**Robatel Technologies Responses to the NRC Request for Additional Information
for the Model No. RT-100 Package / Docket No. 71-9365**

Chapter 3 – Thermal Evaluation

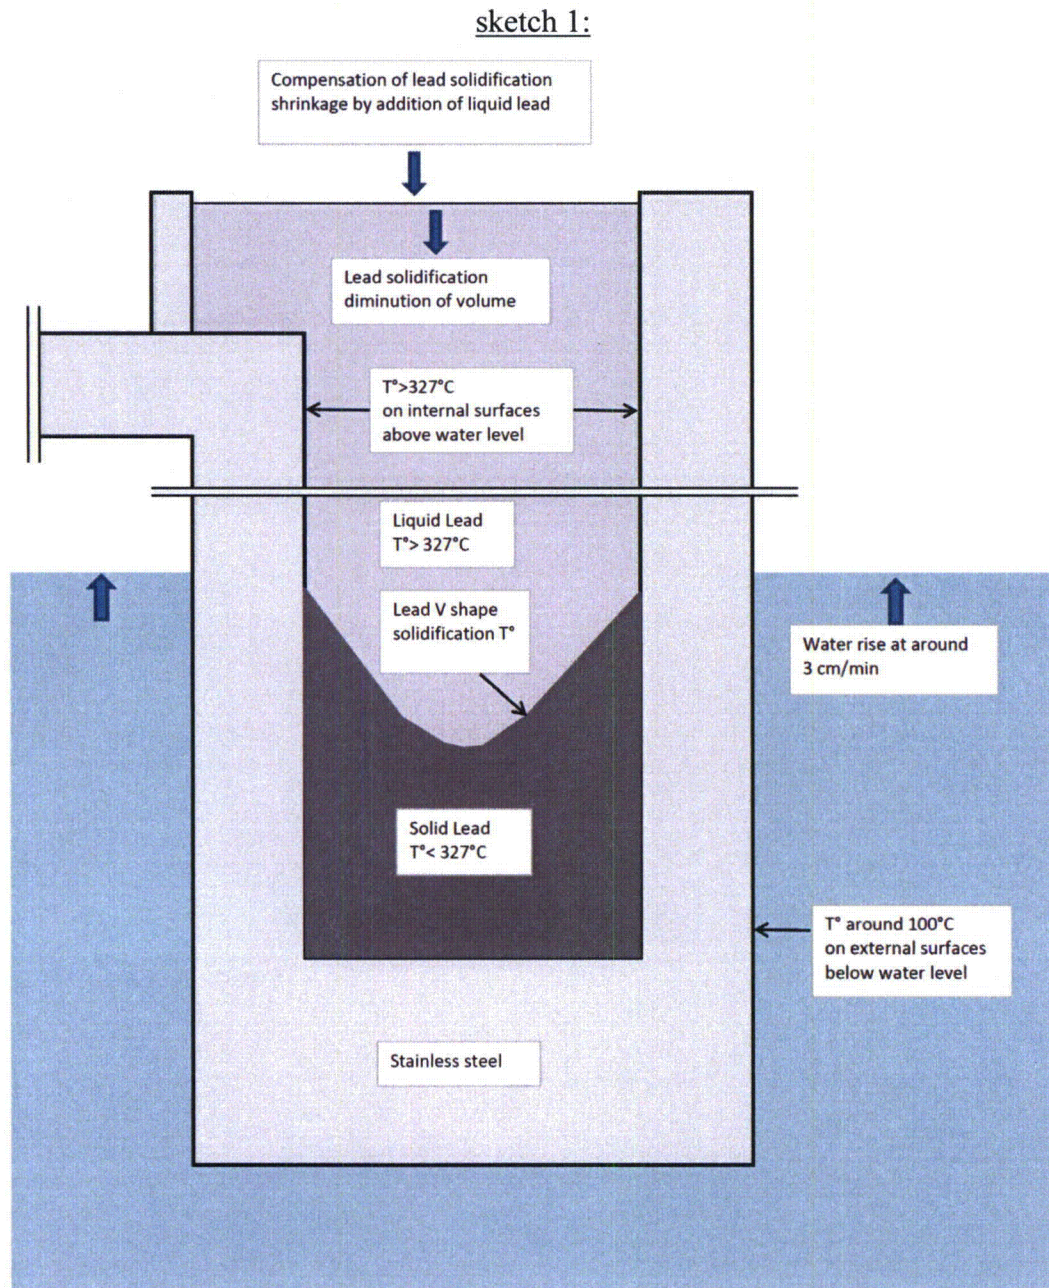
Explain the basis for assuming the additional 1 mm annular air gap between the lead shield layer and the shells housing the lead layer of the Model No. RT-100 package; justify the adequacy of the subsequent 2.478 cm lead slump assumption; recalculate the lead slump if necessary, and provide an updated loading table for various contents based on the updated lead slump.

The staff requests the applicant to provide: (1) a justification for the assumed lead gaps under both NCT and HAC, (2) correct the data if necessary, and (3) recalculate the dose rates for the package under both NCT and HAC.

Liquid lead is poured in the gap between the two (2) pre-heated shells. At this stage, the lead fills the cavity completely (within the specified geometry tolerances). The manufacturing tolerances ensure that the gap between the inner shell and the outer shell is 90 +5/-4 mm.

Chapter 8, Section 8.1.6 of SAR, Rev. 2 has been revised to state that gap is measured to be at least 86 mm prior to lead pouring operations. Therefore, the thickness of liquid lead is at least 86 mm and there is no gap between the liquid lead and the shells.

Figure 5.4.4-1 NCT Dose Rates for the Maximum CO-60 Loading of 741.4 Ci

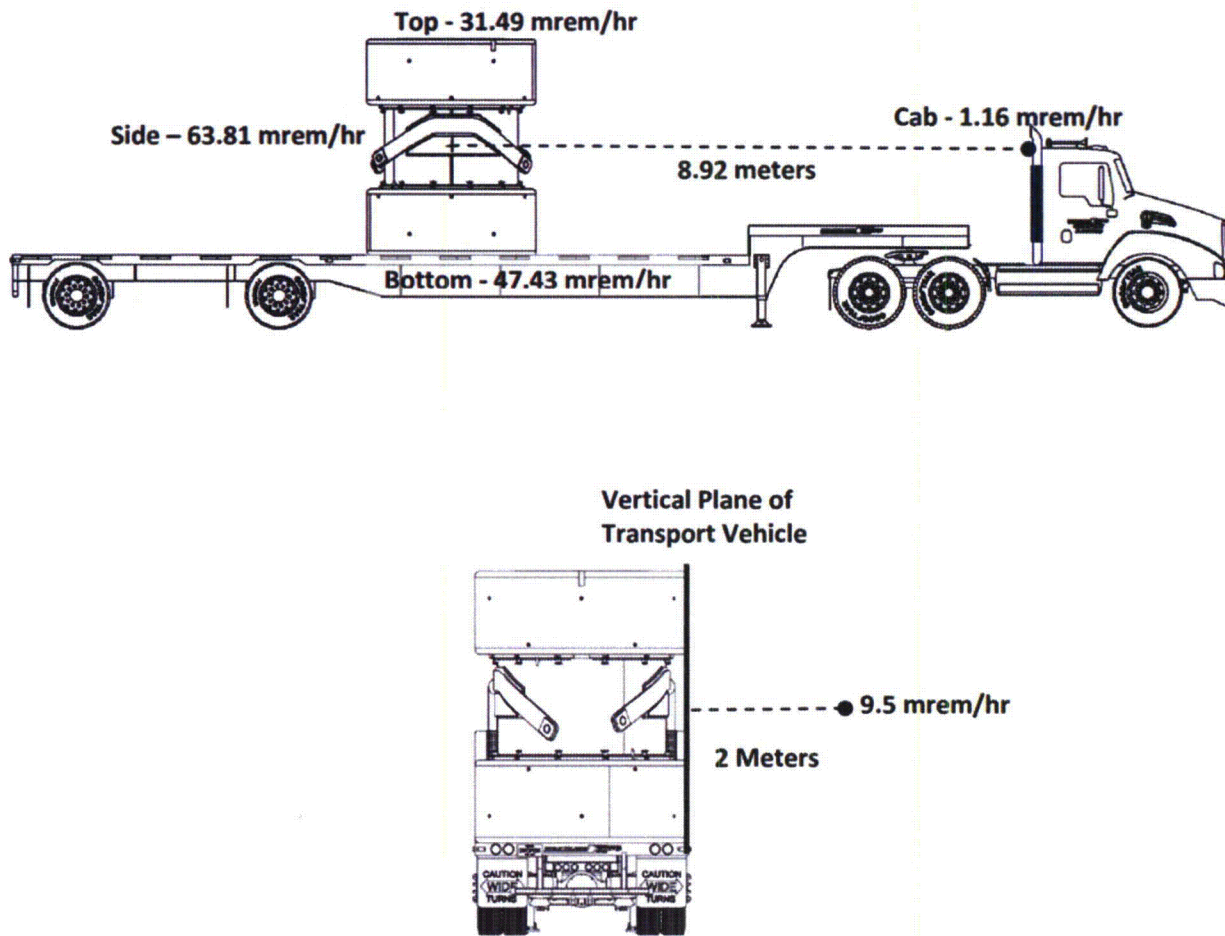
Clarify if the package is transported with an enclosure or a personnel barrier. If neither of these devices are used, provide a justification for using the dose rate at 3219.2 mm from the cask centerline of the package for demonstration of compliance with 10 CFR 71.51(a)(1).

It is intended that the package be in compliance with 10 CFR 71.47(b)(2). Table 5.1.2-1 of the SAR has been revised to provide a reference 10 CFR 71.47(b)(2) rather than 71.47(a).

Figure 5.4.4-1 (reproduced below) has been added to the Chapter 5, Section 5.4.4 to provide additional clarity on where the doses for exclusive use shipment are taken
